TRAILS AT ASPEN RIDGE FILING NO. 2

FINAL GRADING & EROSION CONTROL PLANS

NOVEMBER, 2019

DESIGNED BY: NMS	SCALE: N/A	DATE ISSUED: NOVEMBER 2019	DRAWING No. GEN01
DRAWN BY: CRD	HORIZ: N/A	SHEET: 3 OF 8	
CHECKED BY: NMS	VERT: N/A

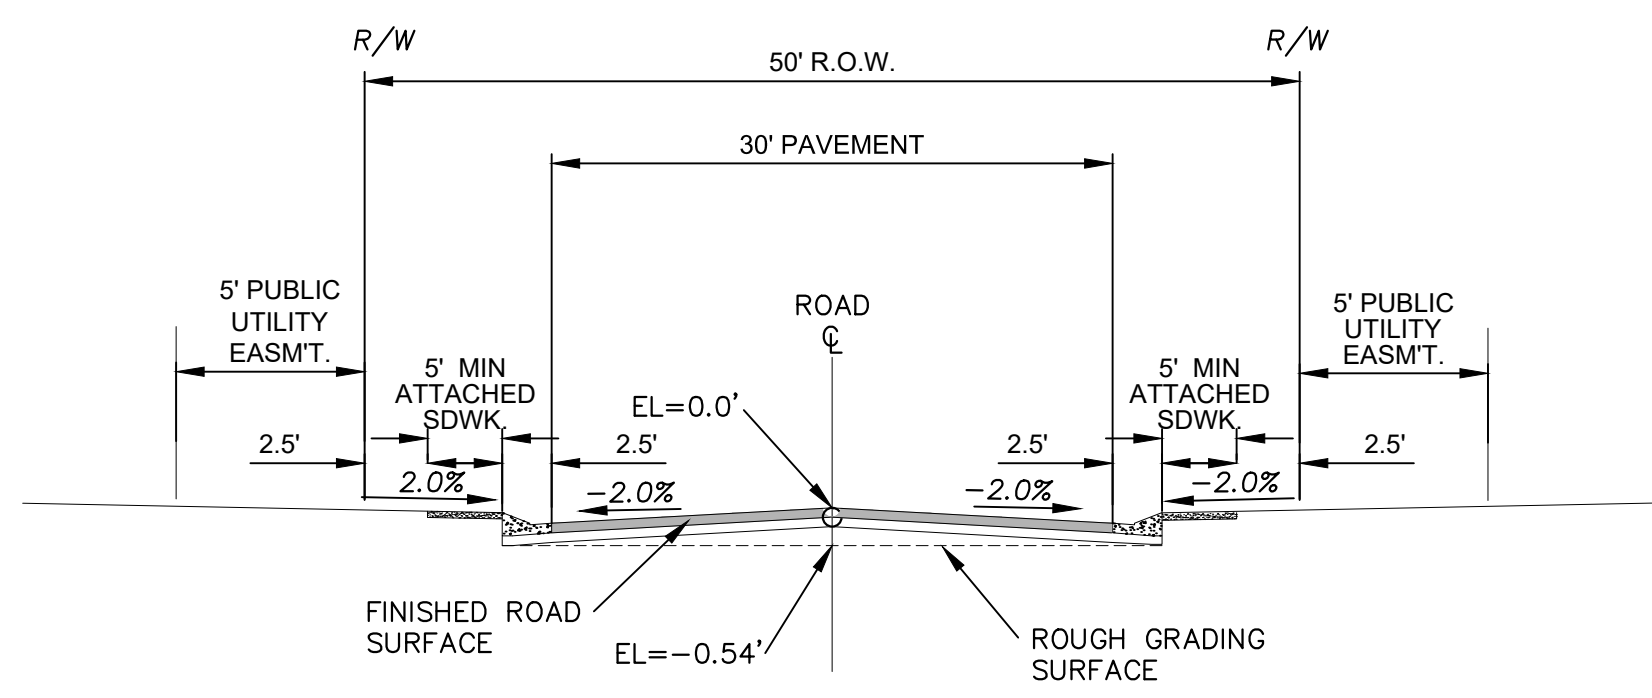
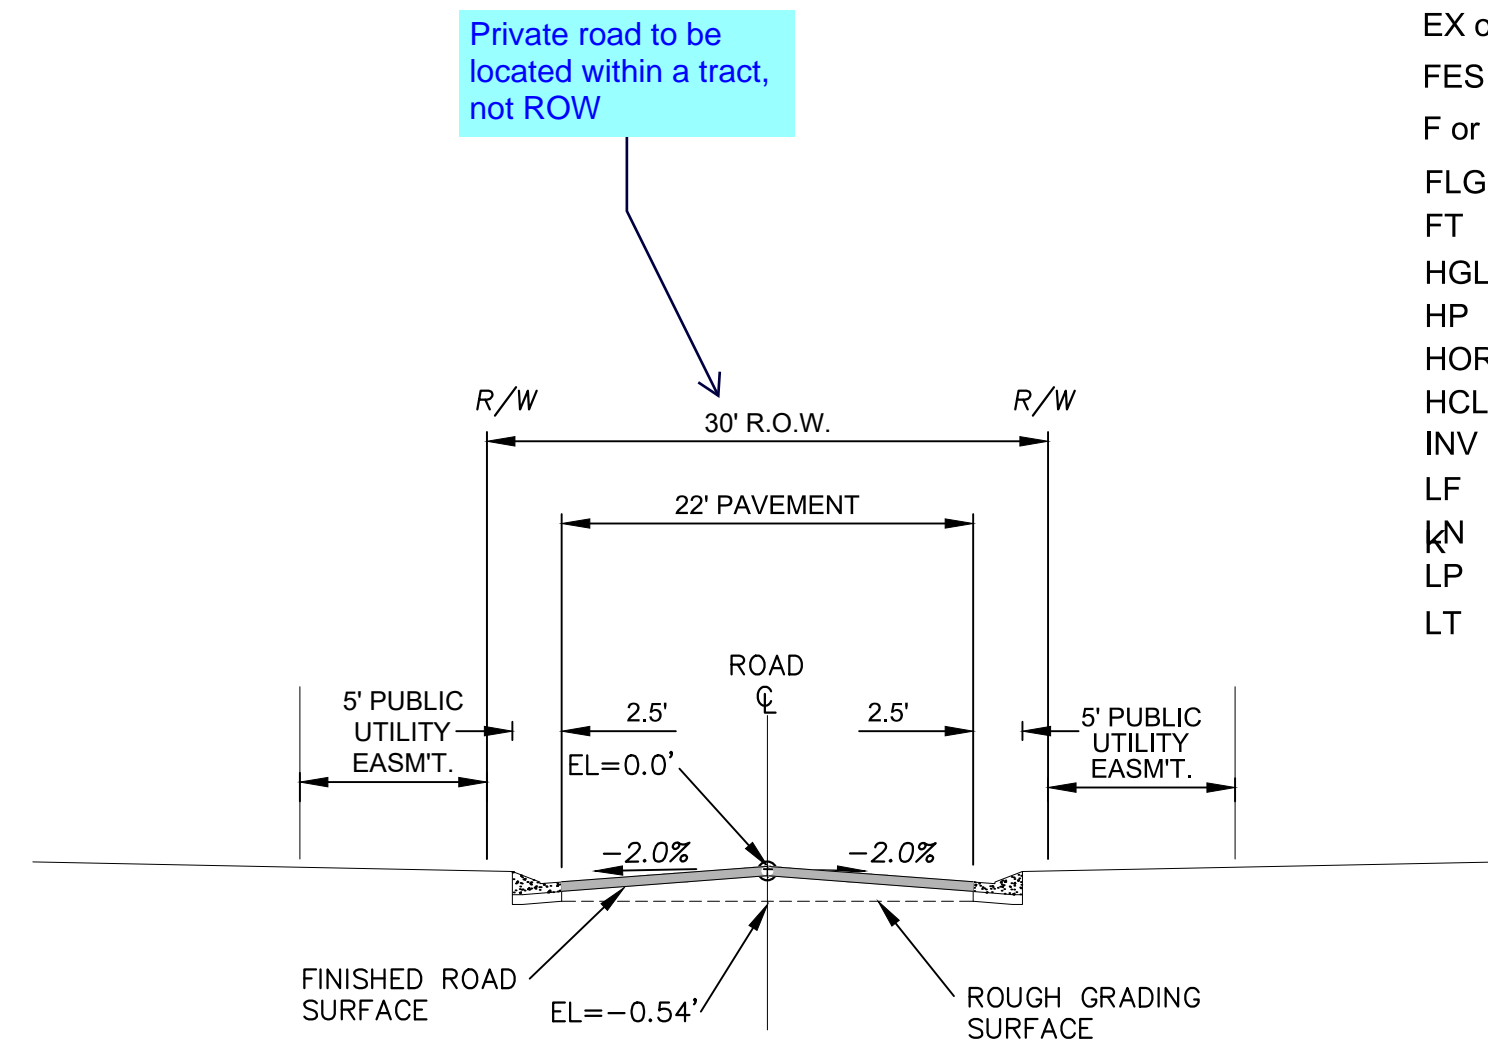
Private road to be located within a tract, not ROW

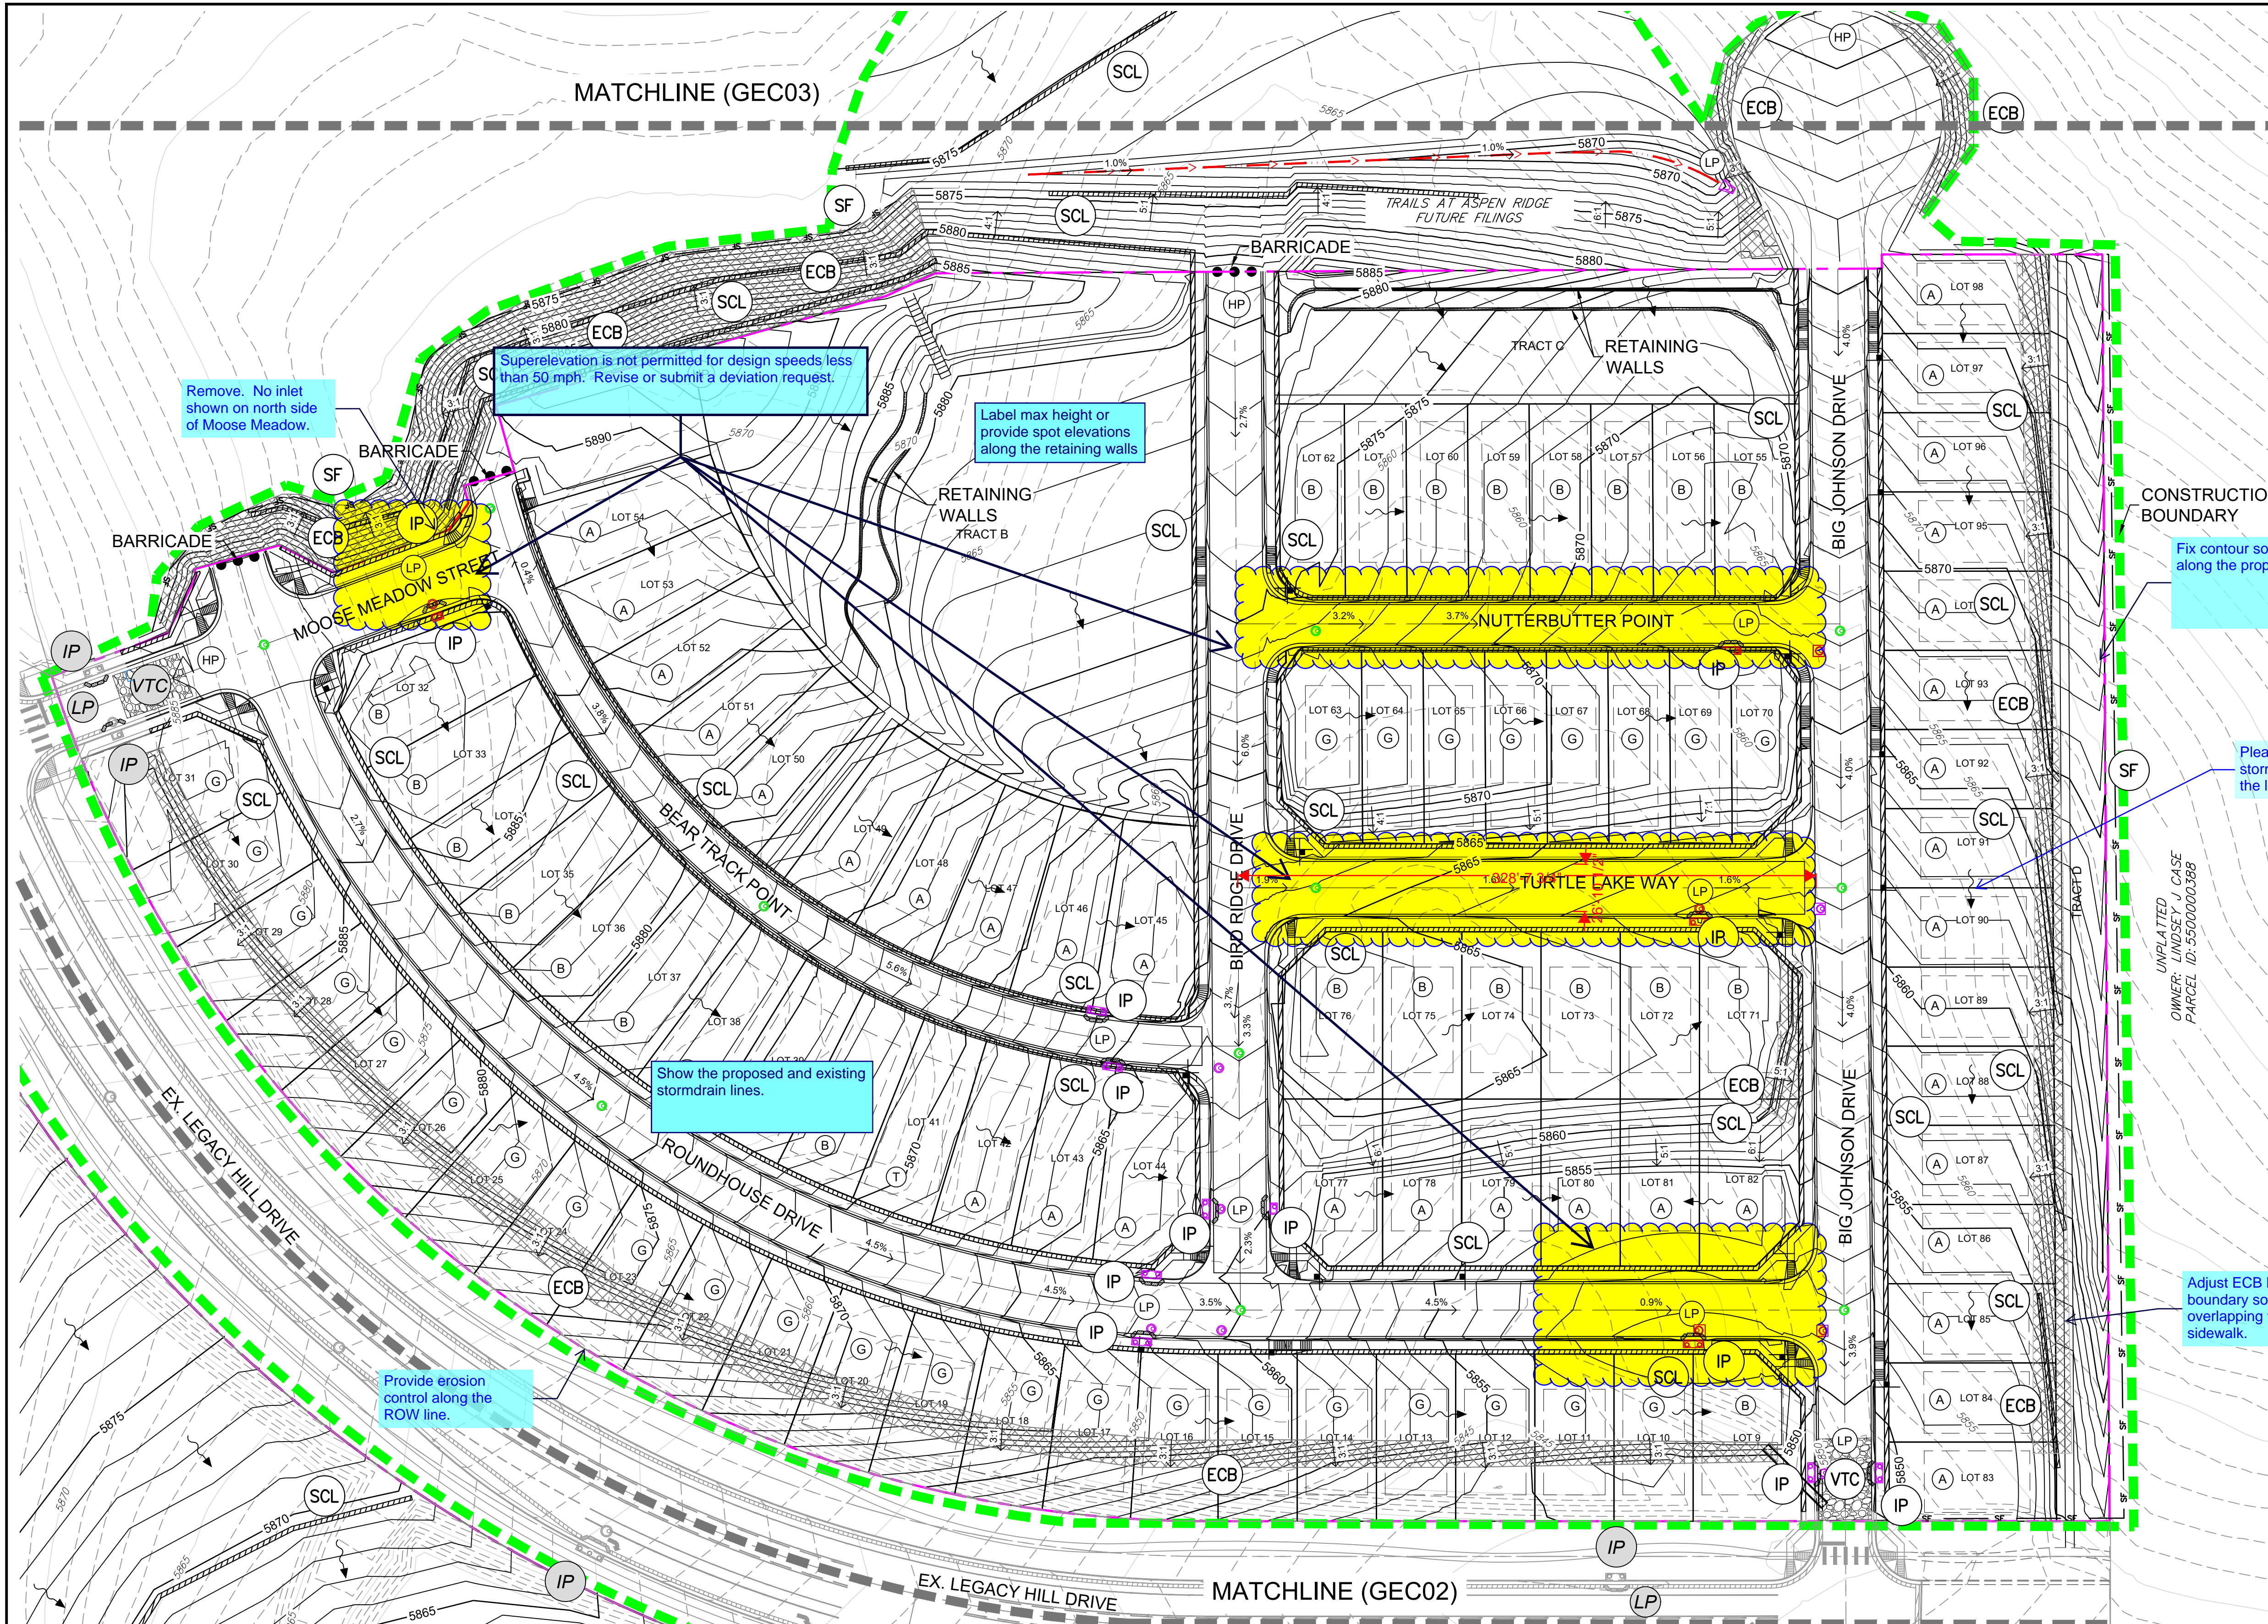
Remove. No inlet shown on north side of Moose Meadow.

Superelevation is not permitted for design speeds less than 50 mph. Revise or submit a deviation request.

Label max height or provide spot elevations along the retaining walls

Fix contour so it doesn't show berm along the property line.

Please add these stormflow arrows to the legend.

Show the proposed and existing stormdrain lines.

Provide erosion control along the ROW line.

Adjust ECB hatch boundary so it's not overlapping the sidewalk.

TRAILS AT ASPEN RIDGE			
FILING NO. 2			
FINAL GRADING & EROSION CONTROL PLANS			
GRADING & EROSION CONTROL PLAN			
DESIGNED BY:	NMS	SCALE:	DATE ISSUED:
DRAWN BY:	CRD	HORIZ:	NOVEMBER 2019
CHECKED BY:	NMS	VERT:	SHEET
			DRAWING No. GEC02
			5 OF 8

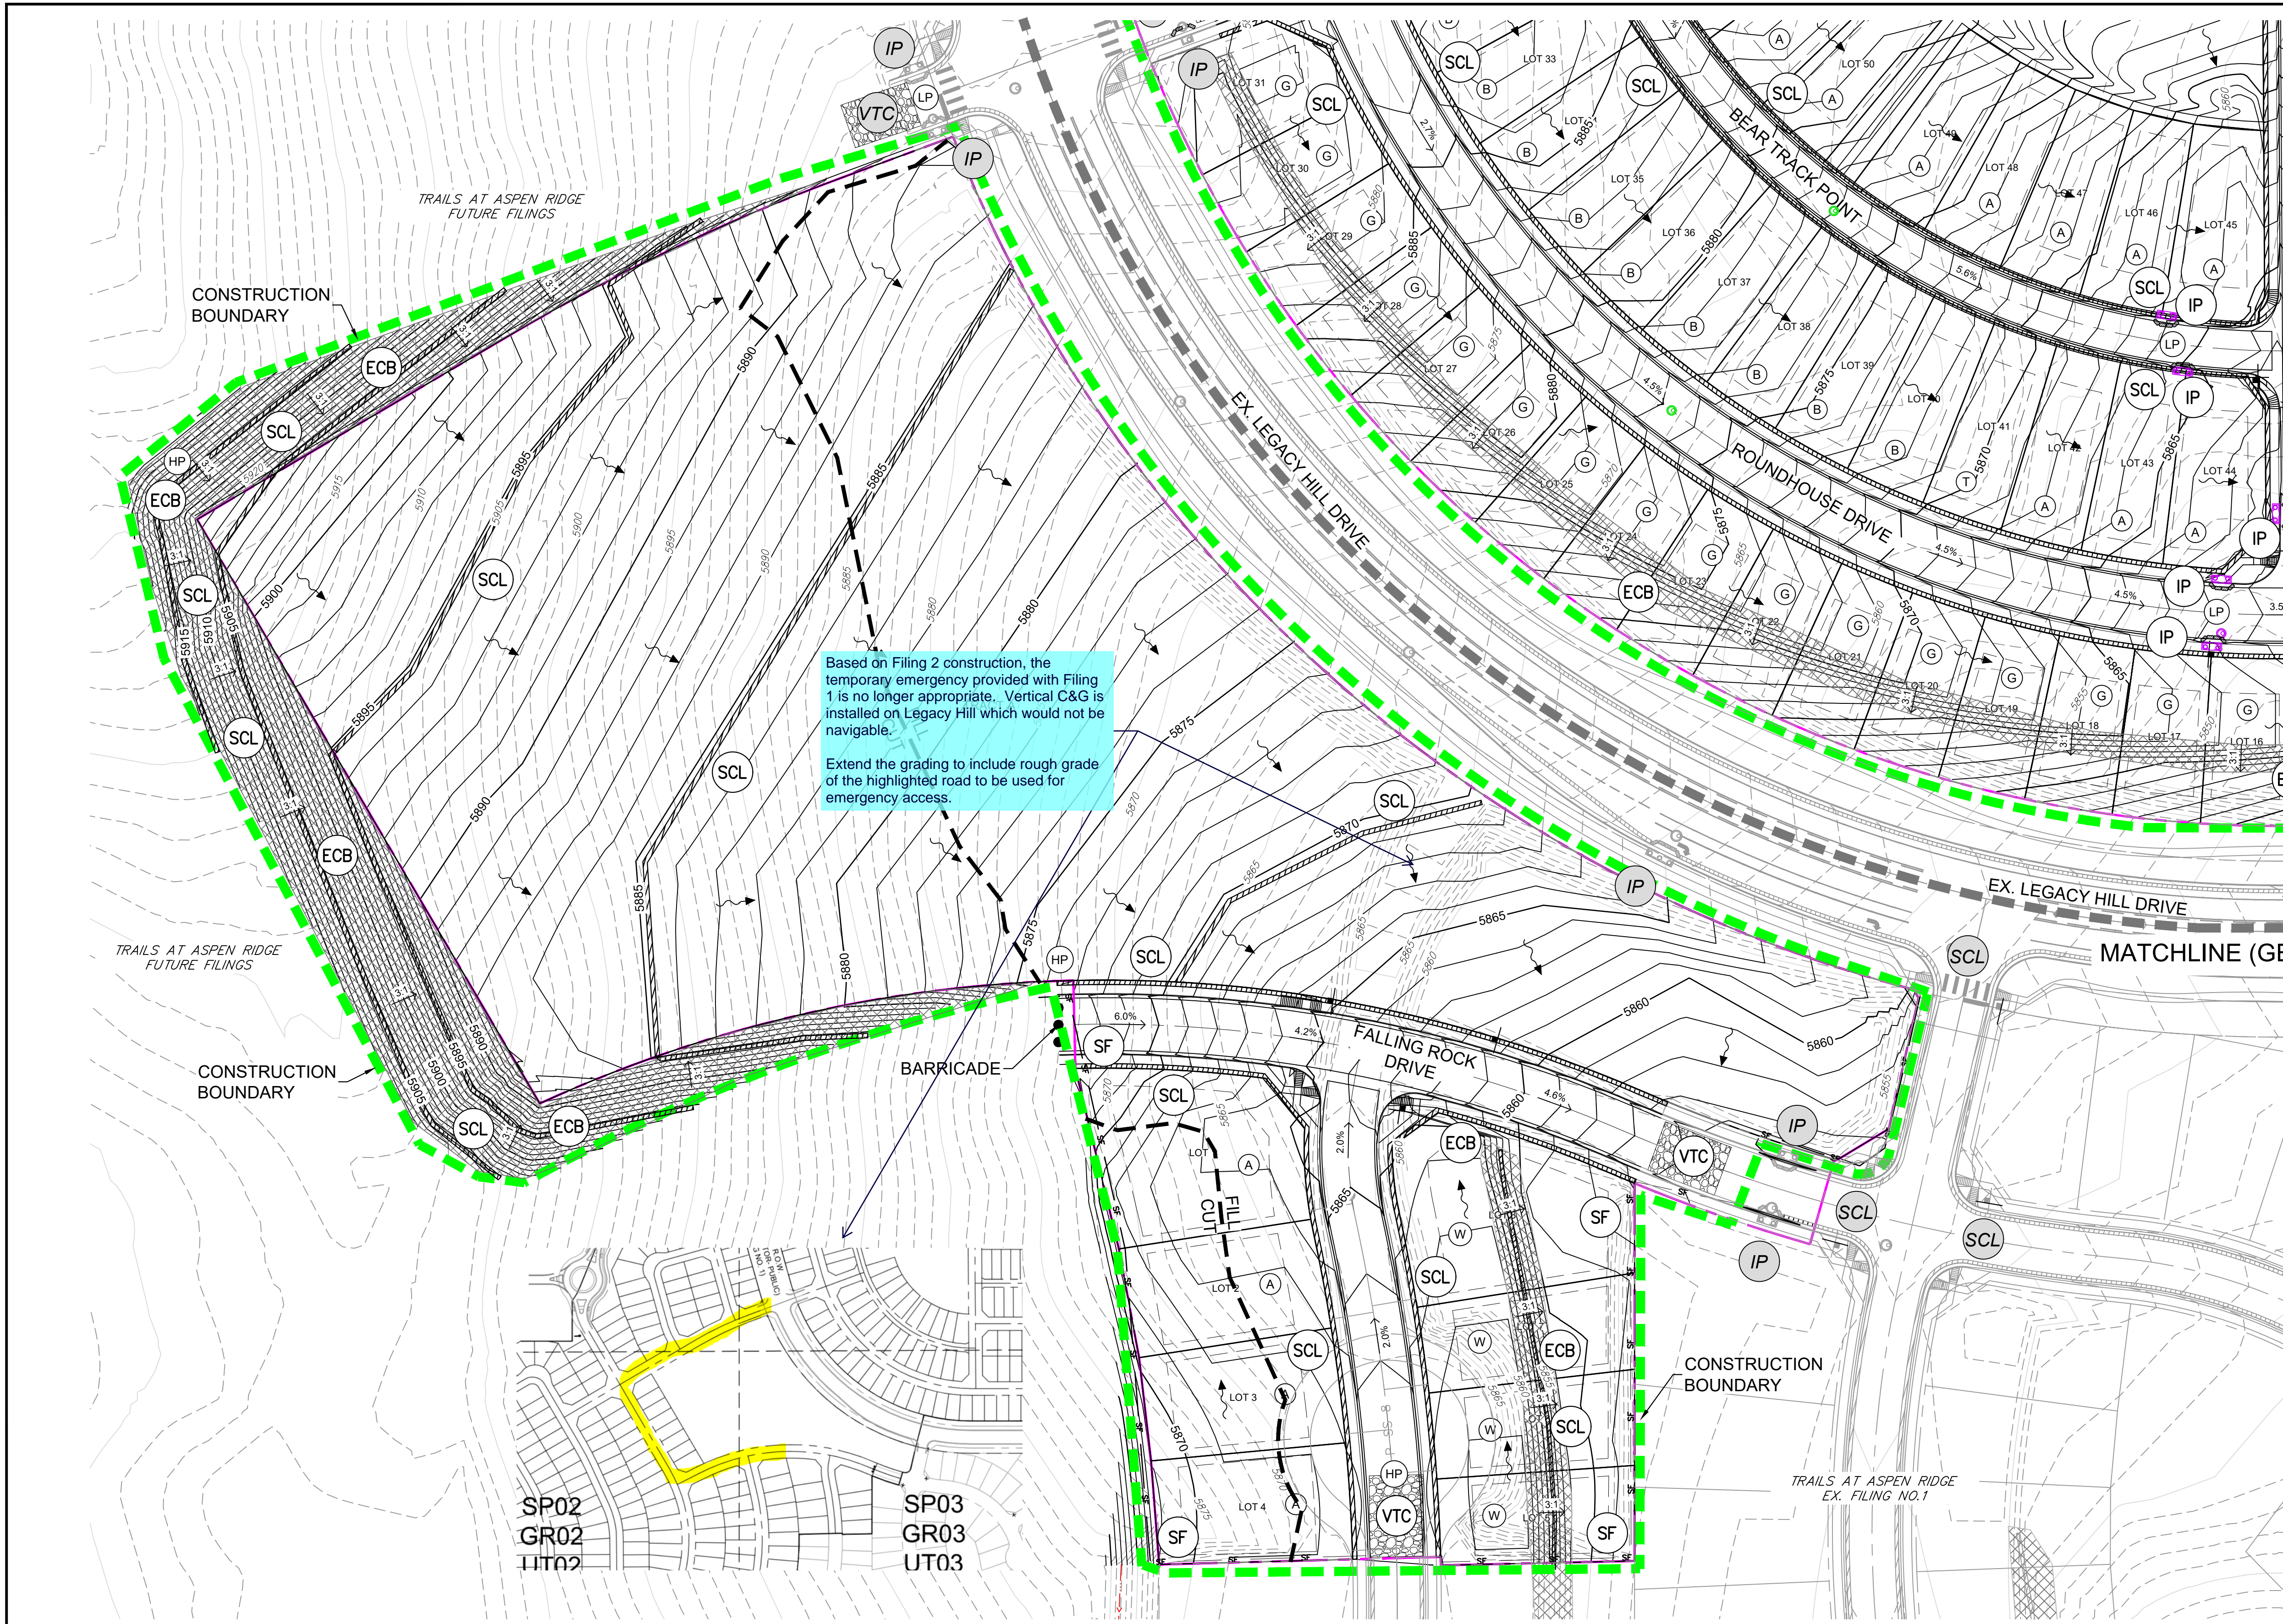
Temporary sediment basins should be provided in your initial sequence.
